Tata Power- Comments on Draft DSM Regulations 2024- PART A

Tata Power- Comments on Draft DSM Regulations 2024- PART B (Detailed

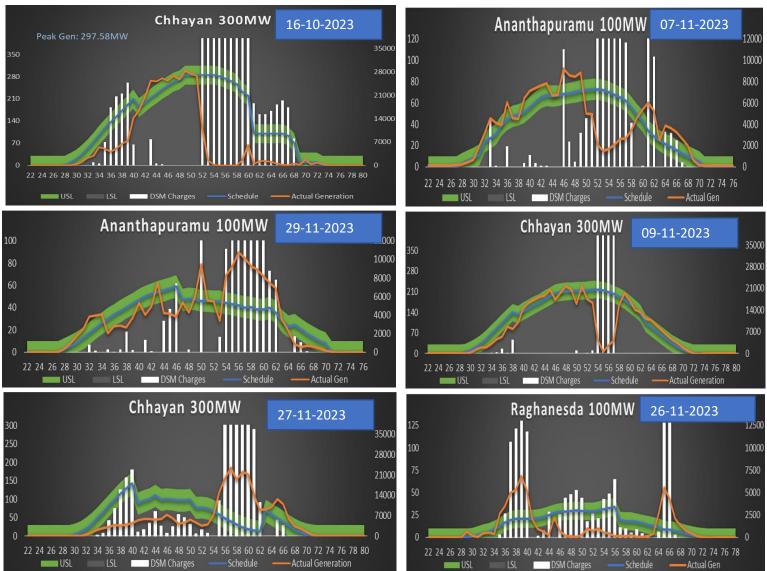
a) Some of the Situations where the deviations have gone beyond 20% band –

- Although 5% to 7% of the time blocks goes beyond 20% band, the charges accountable for these blocks are in the range of 60% to 80% of the total DSM charges. Most of the cases are un -avoidable & not in the control of the generators due to weather uncertainties. Some of the typical cases are shown above. Hence, providing zero beyond 20% band in either case (under injection & over injection) is not advisable, therefore we request to provide 50% of the revenue for the cases beyond 20% band.
